# MEMORANDUM

May 6, 2015

**SUBJECT:** Public hearing and consideration of a Landmark Alteration Certificate to remove a second-story gambrel roof at the rear addition and in its place to construct a 529 sq. ft. second story on the contributing house at 801 Maxwell Ave. in the Mapleton Hill Historic District pursuant to Section 9-11-18 of the Boulder Revised Code 1981 (HIS2015-00080).

Figure 7. Proposed second level addition, 2015.

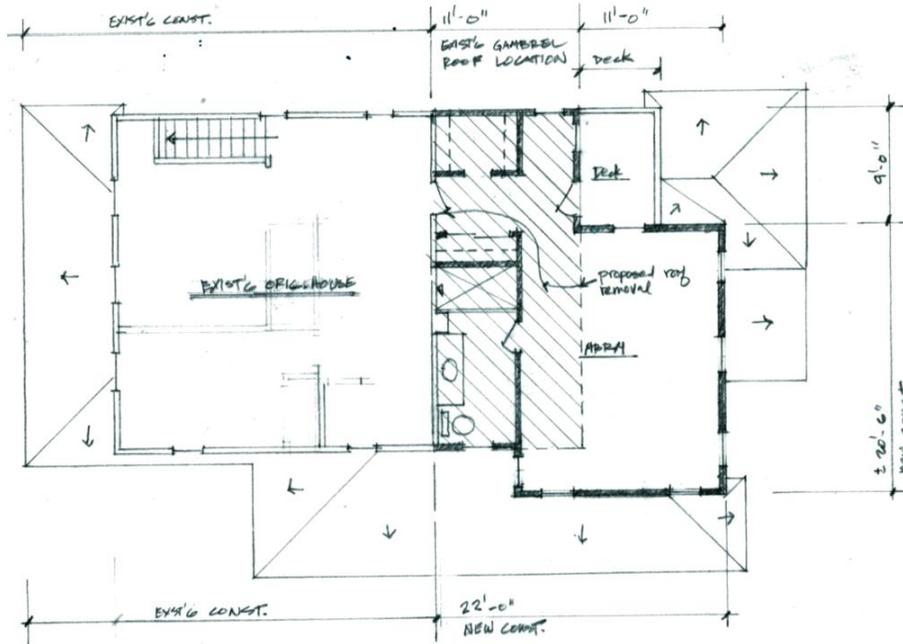
A proposed site plan of the second level shows the removal of the 286 sq. ft. Gambrel roof section replaced with an addition that will add an additional 243 sq. ft. to make the house 2,602 sq. ft. The garage is 220 sq. ft. With the proposed addition, the floor area on the property will be approximately 2,822 sq. ft. The maximum allowed in this Residential Low-1 (RL-1 zoned district is 3,494 sq. ft. The proposed alterations will not expand beyond the existing footprint of the house.

Figure 8. Existing north elevation, 2015

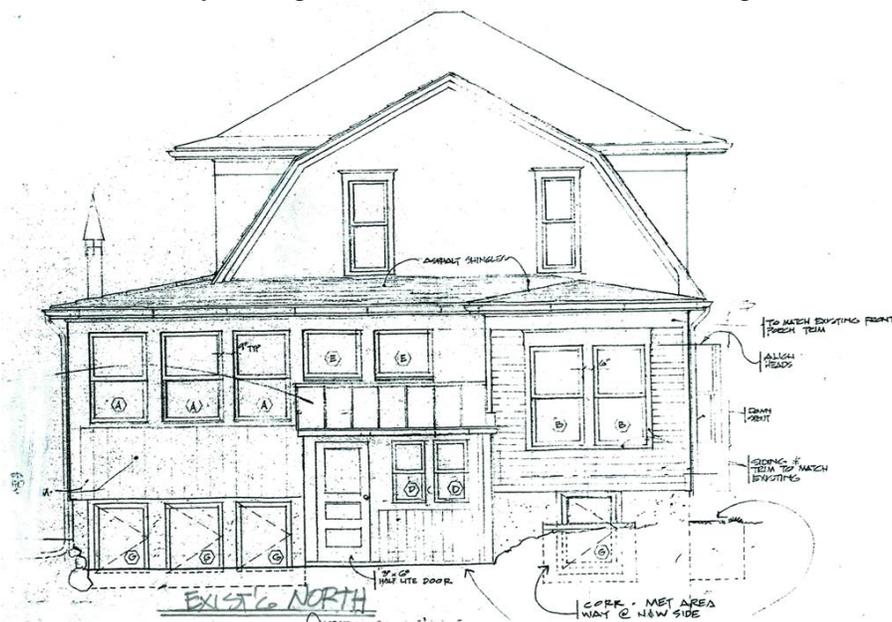
The fenestration of the first level of the north (rear) elevation are shown to be left intact with the second story to feature a clipped hip roof and to be fenestrated with one over one, double-hung windows and a small balcony at the west side shown to be accessed by a single door on north face of the original house.

Figure 13. Proposed east elevation, 2015

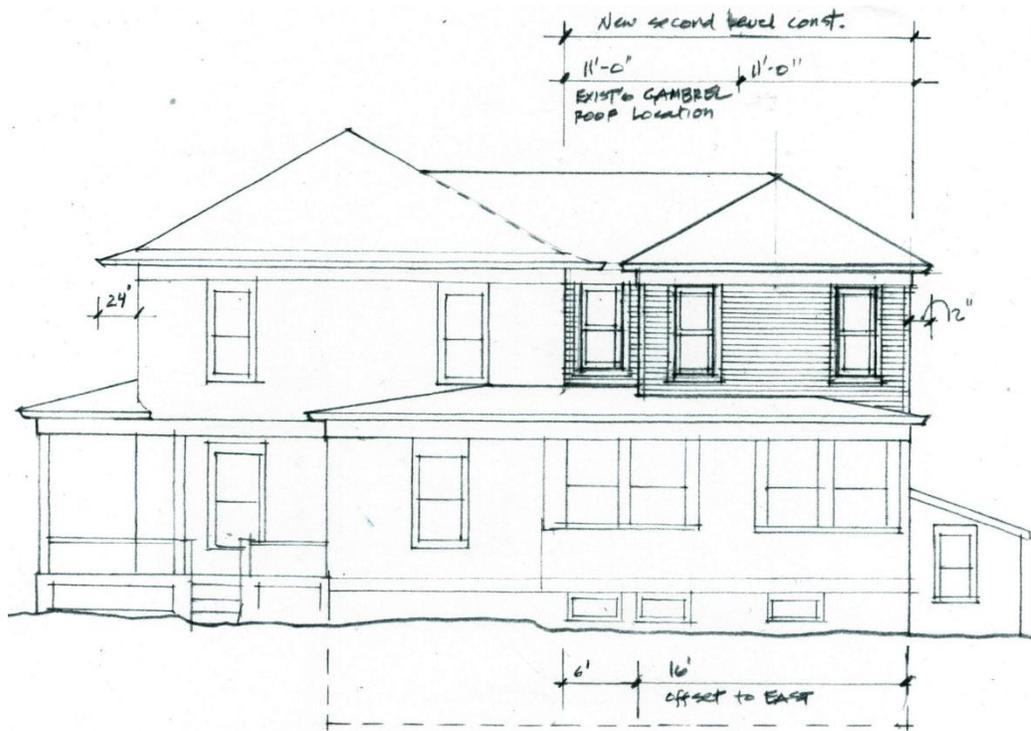
The proposed addition is shown to extend approximately 4 ft. east from the east wall of the Four-Square portion of the house. This new wall is shown to feature a tow over two, double-hung window and will have some visibility from Maxwell Avenue.
